# CONSTRUCTION MANAGEMENT PLAN (CMP) PROPOSED AMENDMENTS

Public Consultation Event (No 2.)  
18:00 – 19:30  
30th October 2019

- What's 'changed'?

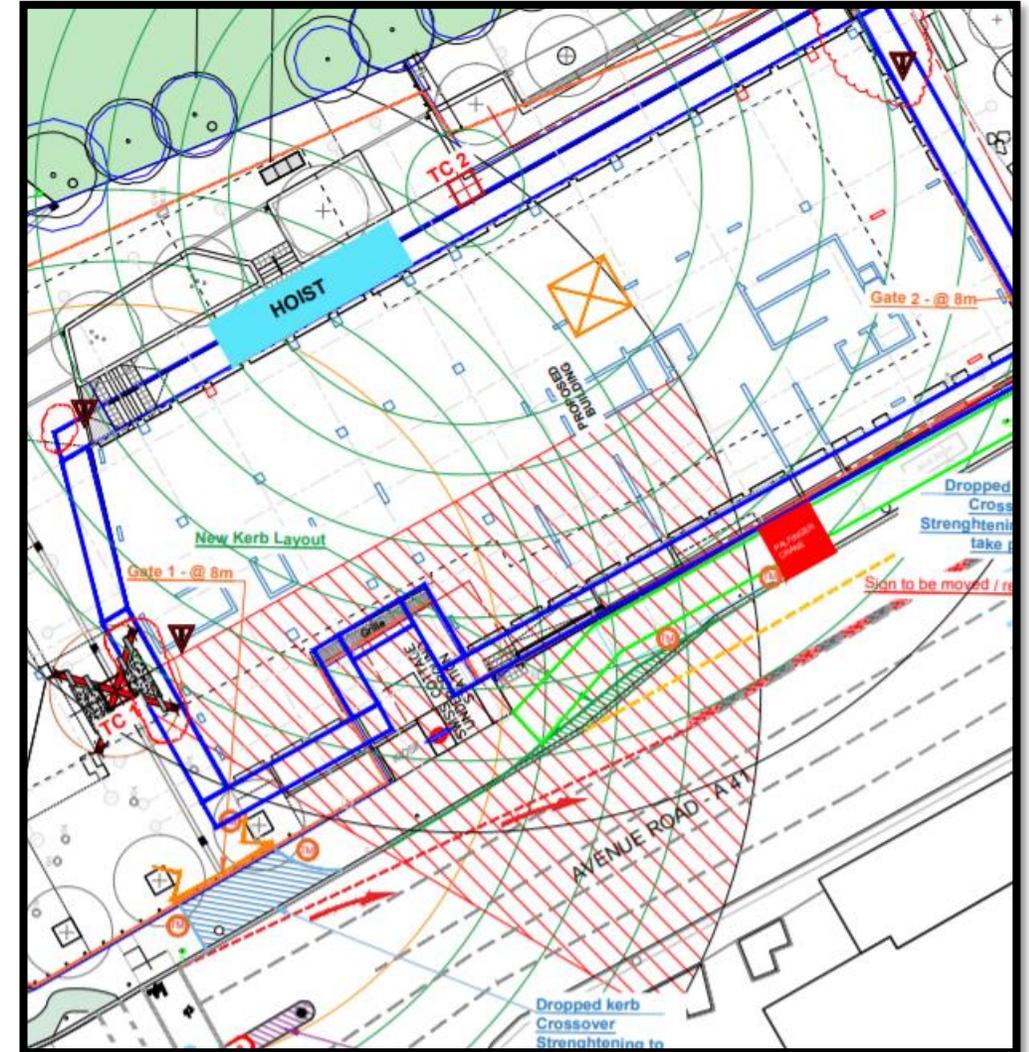
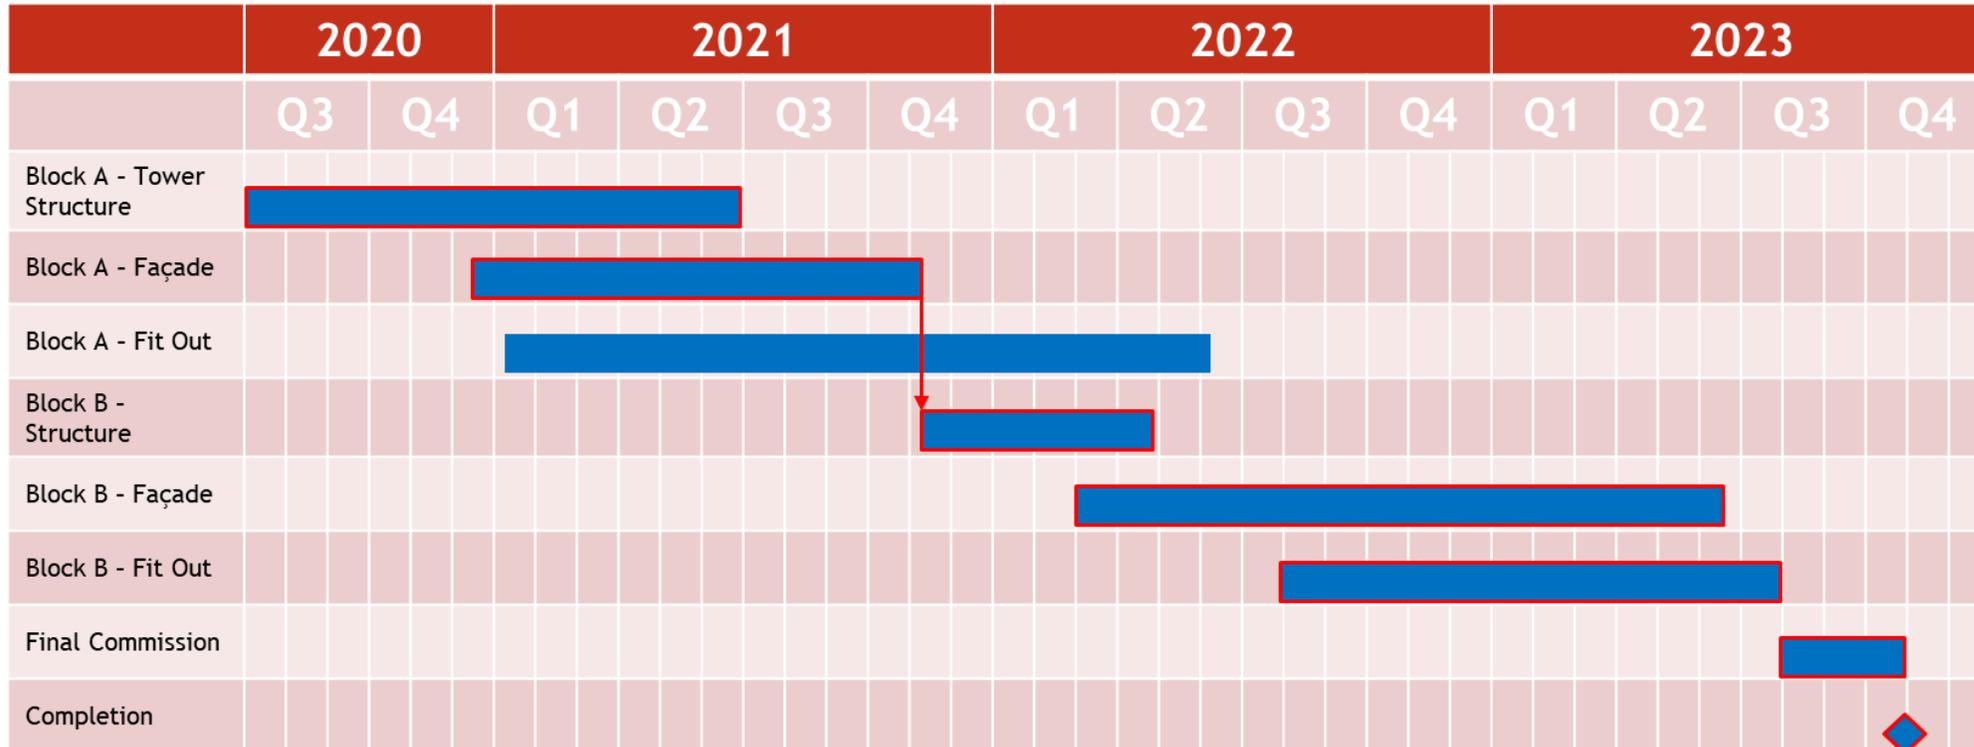
- What's 'changed'?
- The London Underground (LUL) Interface – We have been informed by LUL that the crane which constructs the tower building is not allowed to pass over the London Underground A41 Avenue road entrance after review with the London Underground Limited (LUL).
- The original Construction Management Plan is based on the crane lifting larger materials from the Pit lane over around the LUL entrance but the mast would pass over the asset.
- This impacts the crane lifting plan as one of the cranes cannot use the A41 pit lane which in turn impacts overall Programme and methods of construction.

- The Impact 11 months longer than current programme

- ‘Proposed/ Revised’ Construction Management Plan – Vehicle Numbers per day
- Overall number does not change.

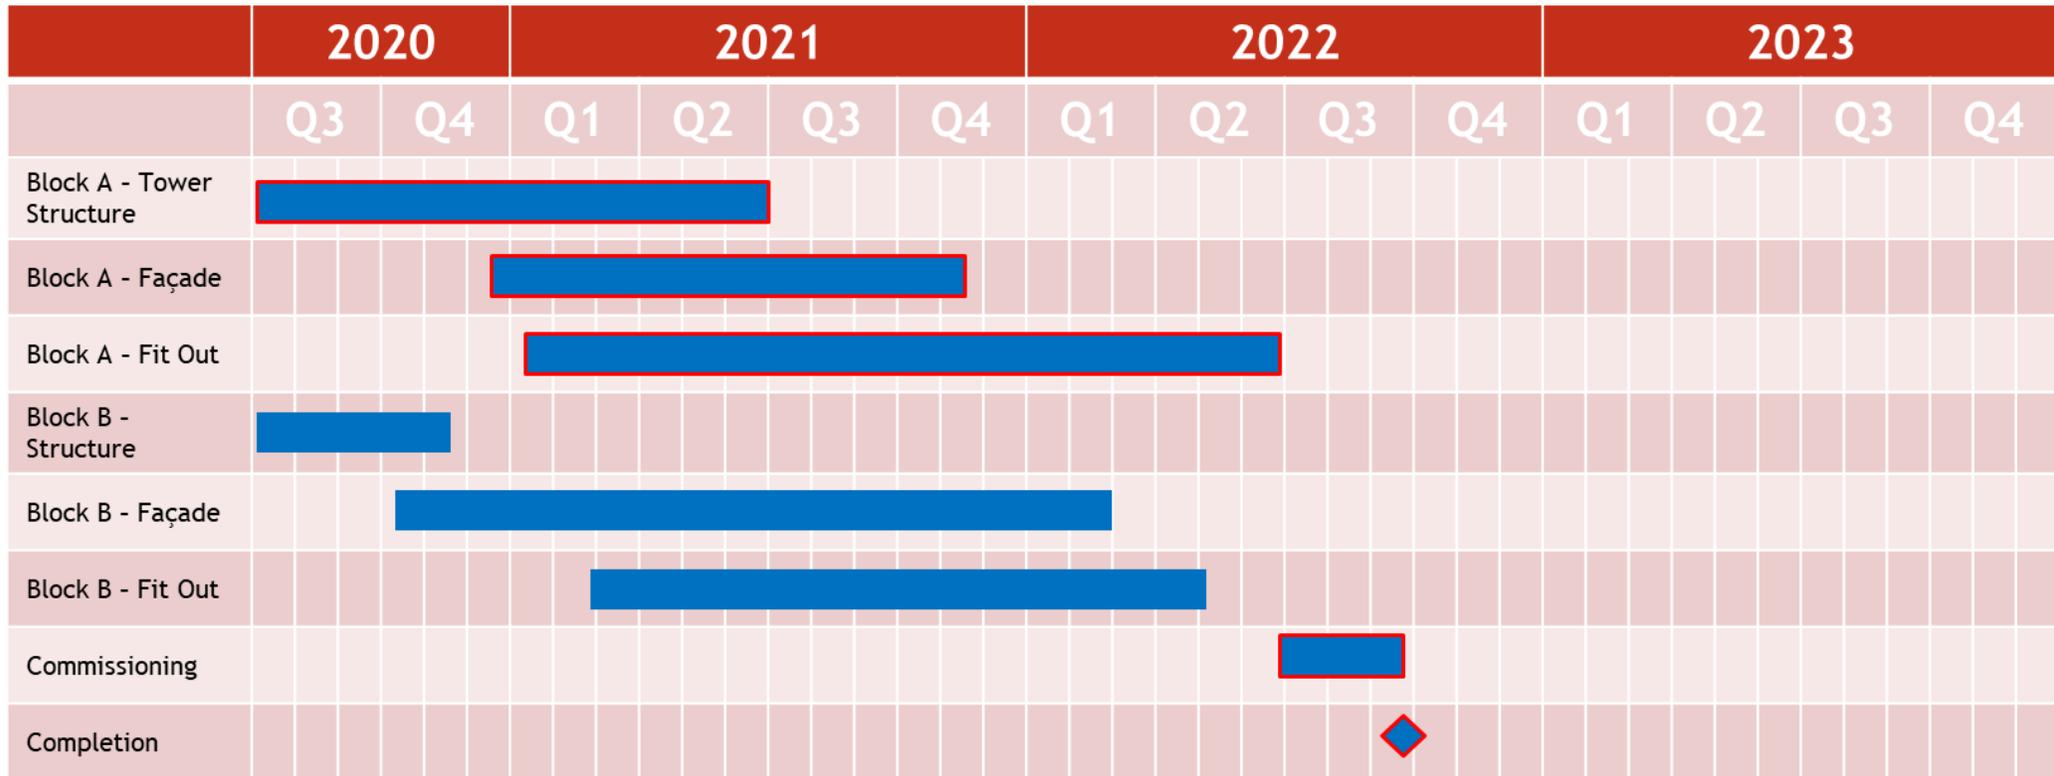
Estimated Daily Maximum Vehicle Movements			Winchester Road (route 6)	Access / Egress onto A41 (route 8)	Total On site Vehicle Movements	Pit Lane	Total Movements
Demolition	Phase complete		14 Max Movements	14 Max Movements	28 Max Movements	0 Max Movements	28 Max Movements
Construction and fit out	Original CMP	30 Months	7 Max Movements	14 Max Movements	21 Max Movements	32 Max Movements	53 Max Movements
	CMP with constraints	40 Months	7 Max Movements	14 Max Movements	21 Max Movements	32 Max Movements	53 Max Movements
	Revised CMP	27 Months	<b>Planned events only</b>	25 Max Movements	25 Max Movements	28 Max Movements	53 Max Movements

- Vehicle movements = 1nr Vehicle in and out
- The plan is based on Delivery Hours Utilising A41 – 8am- 6pm Mon-Fri/ 8am-1pm Sat
- Only ‘Planned and communicated’ use of Winchester Road -This would only be requested in exceptional circumstances for example when the site hoarding is being removed or trees being planted where access from the A41 would not be possible.
- Articulated vehicles to be taken off the A41 and to be off loaded within the site boundary and the Pit lane.
